Thank you for providing us with the 2015 Arterial Asphalt and Concrete (AAC) repaving project 60% plan for Roosevelt Way NE. It's exciting to see the improvements currently planned for the corridor. We do have some comments and concerns regarding the plan.

Sincerely,
Andres Salomon
Seattle Neighborhood Greenways

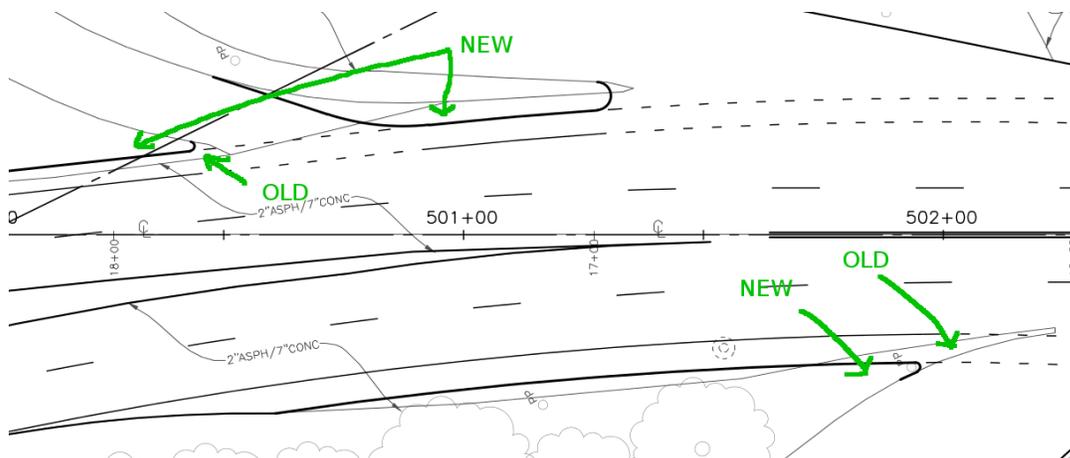
- 3) A protected bike lane between NE 45th St and NE 40th St will be a welcome safety improvement. We're excited to see that the lanes will be implemented as early as this month on a temporary basis, so that they can be monitored and modified prior to the repaving.

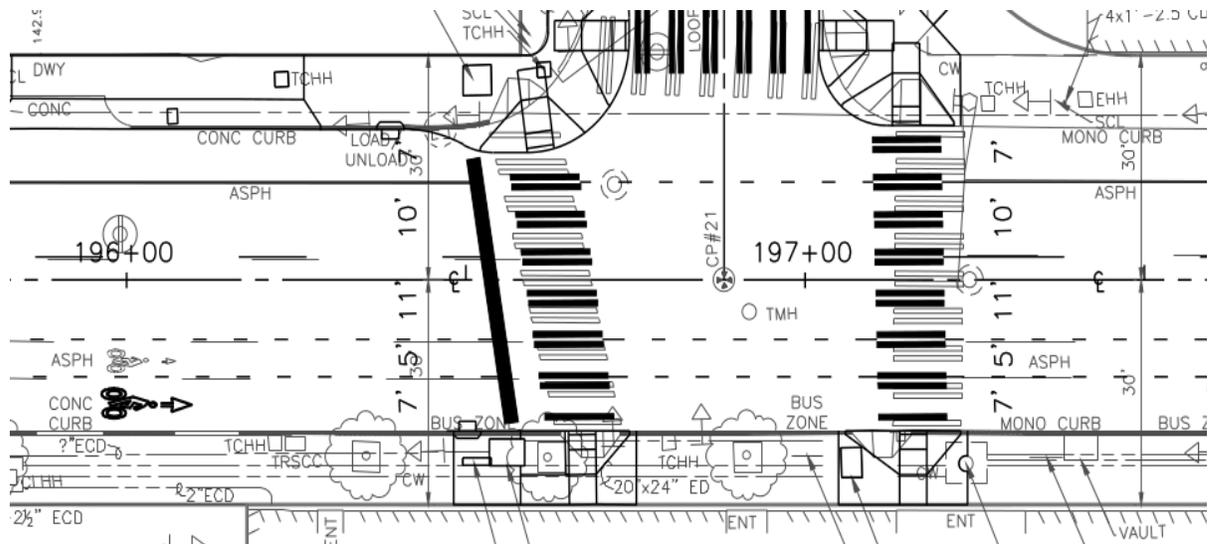
The c-curbs near the bridge will be shaved slightly to allow people on bikes to pass through without being forced to merge with fast-moving cars while also avoiding cars merging from the ramp. This is a huge improvement.

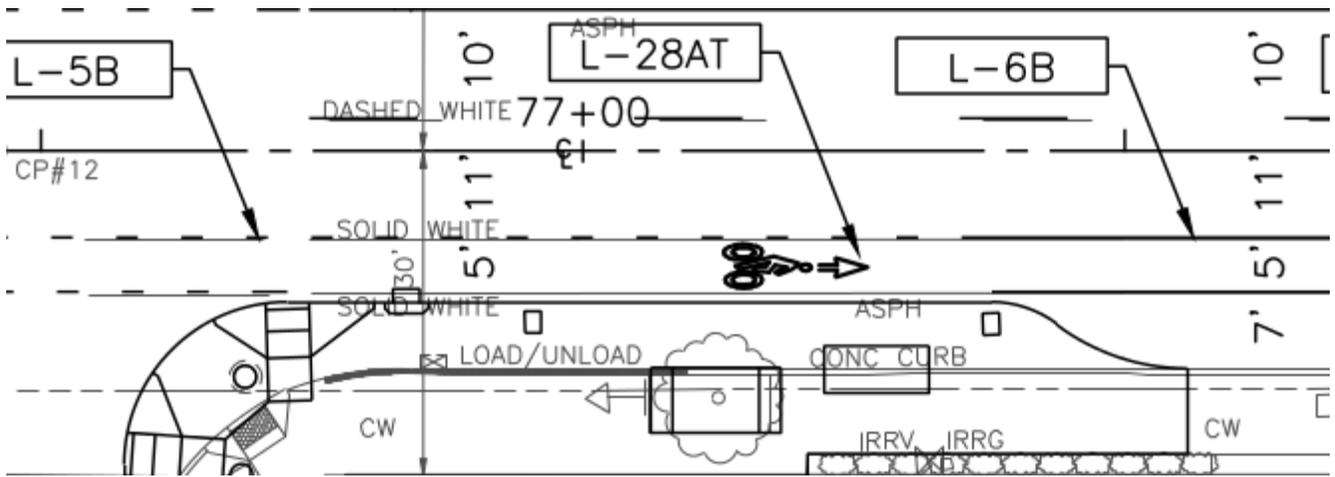
- 2) We are concerned that the removal of a parking lane instead of a general-purpose travel lane will result in a sub-standard protected bike lane, as well as 'bikelash' from nearby businesses. We believe that Roosevelt Way NE should be designed to prioritize the businesses, schools, and homes along the corridor, rather than automobiles attempting to speed through the

neighborhood. Many of the business owners we spoke to were concerned by both the number of collisions that occurred in front of their stores, and their need for parking. The current plan for parking removal on the west side of the street could actually result in additional speed by vehicles, as parked (and parking) cars tend to provide a calming effect.

Additionally, the area in front of UW Medical will lack proper protection for the bike lane, and there will be conflicts with bikes and buses/patient loading. If one of the general purpose travel lanes were to become a bus stop and loading zone, this would resolve the conflicts. These bus stops and loading zones would become in-lane stops in the case of a parking lane with peak-hour restrictions. To leave this segment unprotected would be a failure to build a truly All-Ages-and-Abilities protected bike lane.

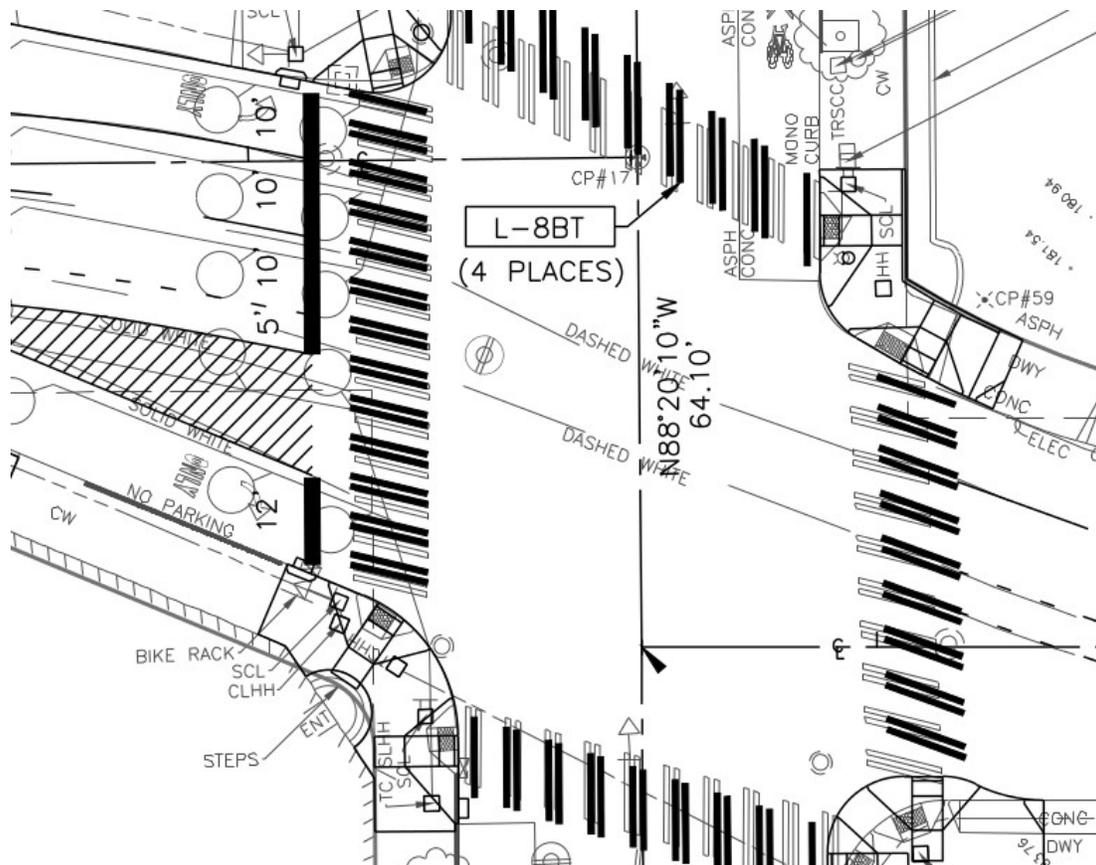
- 4) If we're not going to extend the protected bike lanes immediately, we need to ensure that the 2015 AAC project does not jeopardize future segments of a protected bike lane on Roosevelt. In places where curb bulbs and widened sidewalks are right next to the existing bike lane, we need to plan for the future.

One possibility would be to create bus and load-zone islands, similar to what was built on Dexter Ave. This should be made part of the AAC plans, with the bike lane being routed to the west of a load/unload zone or bus stop. One can imagine a five foot wide bike lane between the existing sidewalk and a seven foot wide island.

In places where the curb bulb is simply too wide, it should be narrowed.

Roosevelt & NE 45th - 60% plans

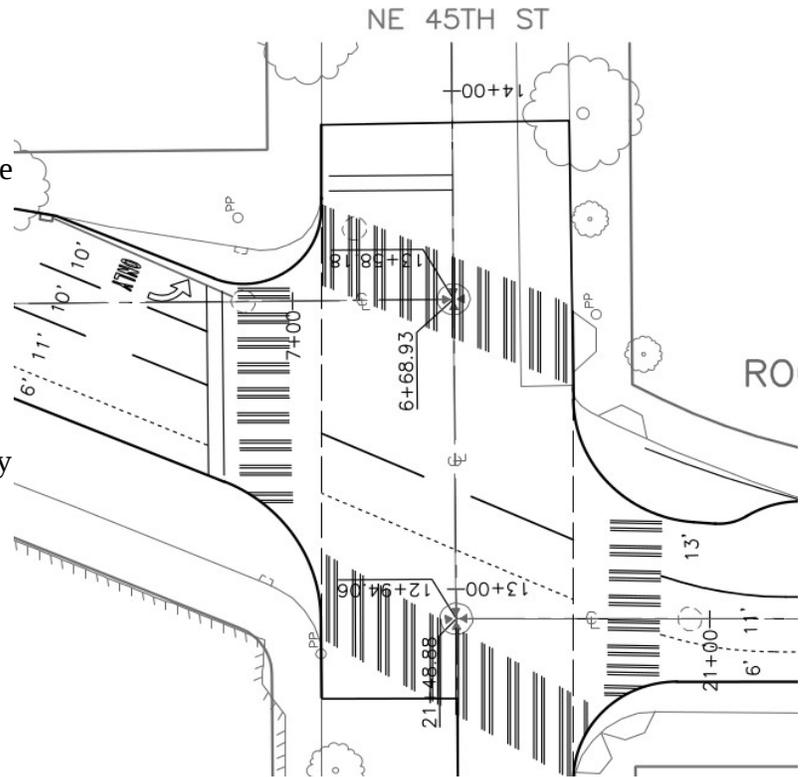
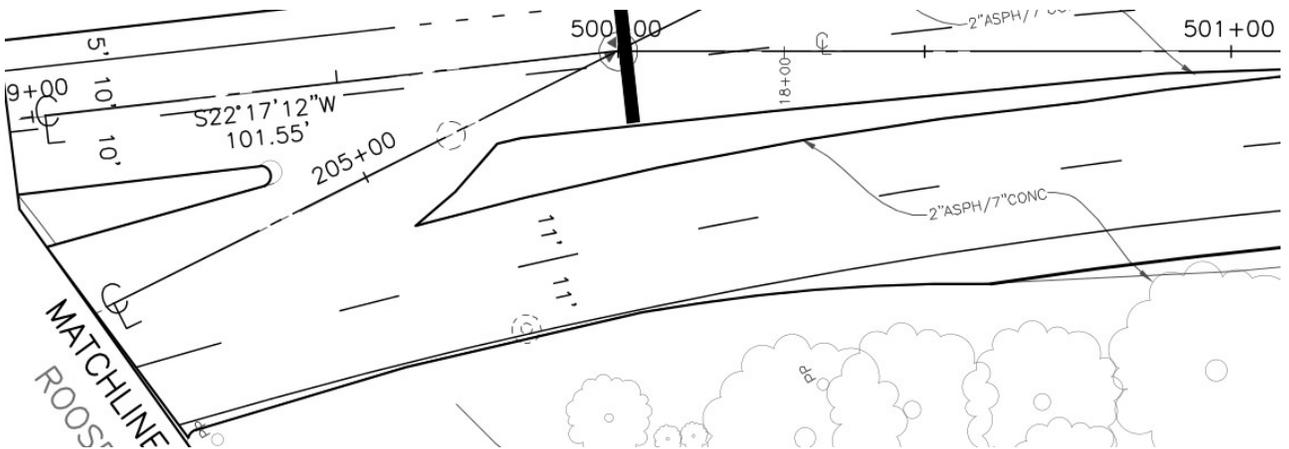
The earlier AAC 30% plans had reduced this intersection of Roosevelt Way NE and NE 45th St down to three lanes, removing the right turn lane on the north side of the intersection and adding a massive curb bulb in its place. We were disappointed to discover that the 60% plans have readded the lane. This intersection is awful to cross on foot, and the painted island does little to help. We recommend removing the right turn lane if possible.

We also would like to see a larger curb bulb on the south side of the intersection, next to the gas station. The gas station has numerous driveways which present a risk to people in the bike lane, vehicles making turns through the intersection, and people walking on the sidewalk and in the crosswalk. If driveway consolidation is possible, that would help greatly. This intersection already has a lot going on, and the driveways closest to it are not helping.

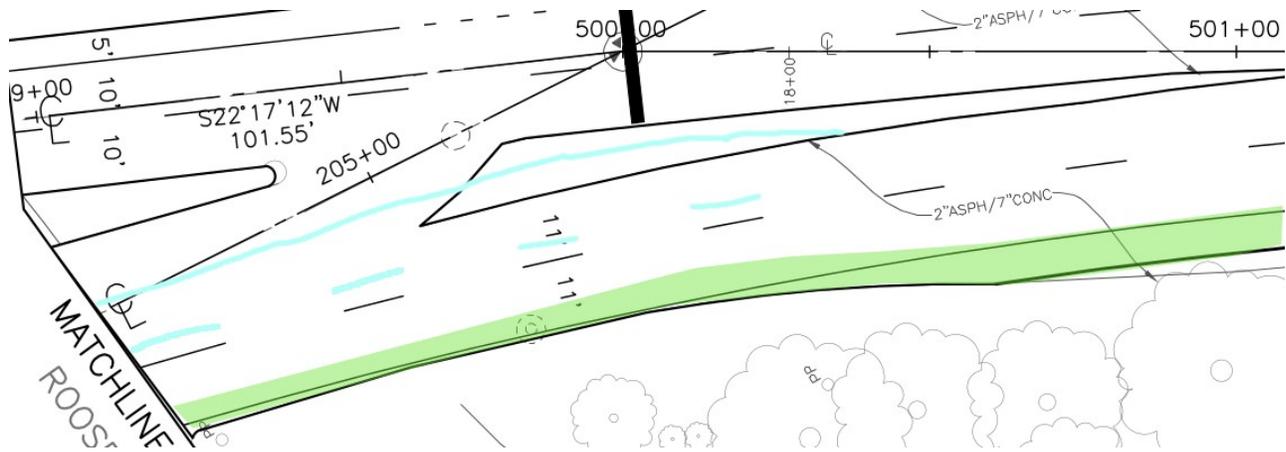
- 6) At NE Campus Pkwy, the bike lane will disappear and bikes will be forced to merge with cars. They will share two 11 foot general-purpose lanes.

We think this needs to be examined more closely. At this segment of Roosevelt, there's a left-

turn lane that appears to be at least 13 feet wide. We think it's worth examining whether it's possible to narrow that lane (keeping in mind that buses turn there, but that they need a wide turn radius, not necessarily a wide lane), as well as narrowing the general purpose travel lanes. If we could free up 5 feet of space, that would allow for an unprotected bike lane.

After the left-turn pocket, the median island could be narrowed to provide additional space for the bike lane.
